ALERT SERVICE BULLETIN

Replacement of the check valve housing on ROTAX® 915 iS A/C24 (Series) and 916 iS A/C24 (Series) Aircraft Engines

ATA System: 78-10-00 Turbocharger

Fig. 1
Parts requirement

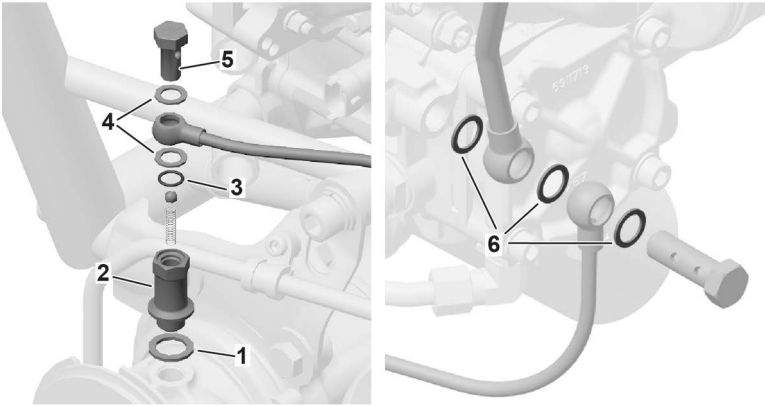
Internal quality checks revealed that there is a deviation in the valve housing and the banjo bolt connection. This could lead to oil leakage at the turbocharger.

Fig.no.	New part no.	Qty/ engine	Description	Application
2-1	250646	1	SEALING RING A12X18-CU	Valve housing
2-2	956492	1	VALVE HOUSING	Check valve
2-3	631140	1	O-RING DIN 3771-8X1,5-N, FPM 80	Valve housing
2-4	950141	2	SEALING RING A8X13	Banjo bolt M8
2-5	840733	1	BANJO BOLT M8X1X18,5	Check valve
2-6	230150	3	SEALING RING A10X14	Banjo bolt M10

Fig. 2
Check valve housing removal

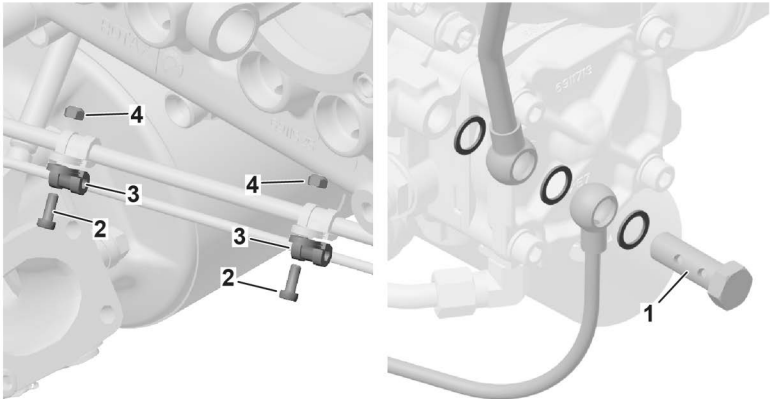
Step	Procedure
1	Remove banjo bolt M10X1X34 (1) from the turbo pressure oil line at the oil pump housing.
2	Remove Allen screws M5X12 (2), lock nuts M5 (3) and cable clamps 5/M5 (4).

Fig. 3
Check valve housing removal

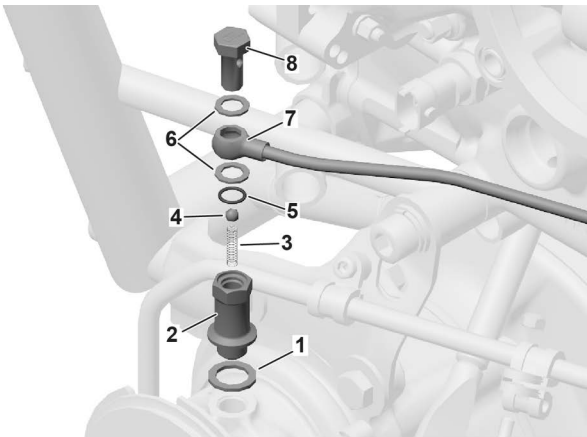
Step	Procedure
3	Remove the turbo pressure oil line (7) with sealing rings (6) by loosening the banjo bolt (8) at the check valve housing (2).
4	Remove the check valve housing (2) with the compression spring (3) and the ball (4) including the O-ring (5) and sealing ring (1). NOTE: Be sure not to lose the ball and the compression spring.

Fig. 4
Check valve housing installation

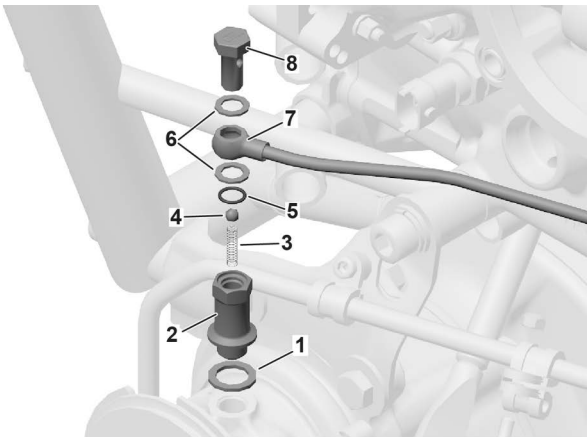
Step	Procedure
1	Install new check valve housing part no. 956492 (2) with new sealing ring A12 (1). Tightening torque 25 Nm / 18 ft.lb. NOTE: New check valve housing is marked with a green dot (paint marking).
2	Place the compression spring (3), ball 5.556 (4) and new O-ring 8X1.5 (5) into the check valve housing.
3	Attach turbo pressure oil line (7) to the check valve housing using new sealing rings A8 (6) and new banjo bolt part no. 840733 (8), hand tighten only.

Fig. 5
Turbo pressure oil line install

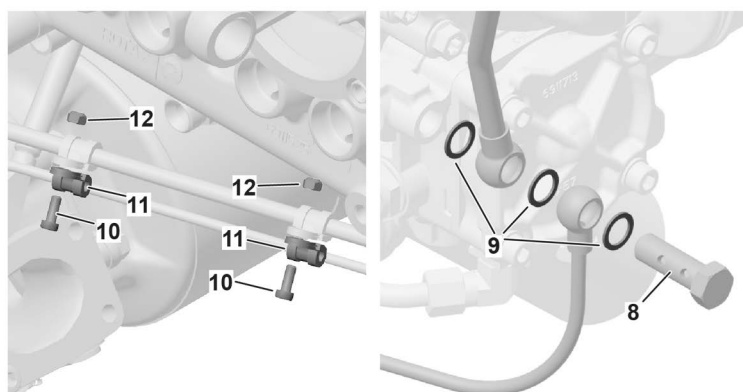
Step	Procedure
4	Attach the turbo pressure oil line at the oil pump housing using banjo bolt M10X1X34 (8) and new sealing rings A10 (9), hand tighten only.
5	Attach cable clamps 5/M5 (10) with Allen screw M5x12 (11) and lock nut M5 (11). Tightening torque 5 Nm / 44 in.lb.
6	Tighten banjo bolt M10 at the oil pump housing (8) to 12 Nm / 106 in.lb. Tighten banjo bolt M8 at the check valve housing.to 17 Nm / 150 in.lb.

Fig. 6
NEW check valve components - 915 i (Series)
and 916 i (Series)

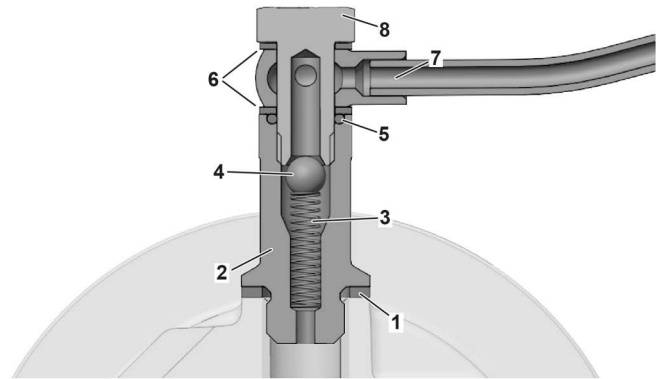
- 1 Sealing ring A12
- 2 check Valve housing 956492
- 3 Compression spring
- 4 Ball 5.556
- 5 O-ring 8X1.5
- 6 Sealing ring A8
- 7 Turbo pressure oil line
- 8 Banjo bolt M8X1X18,5
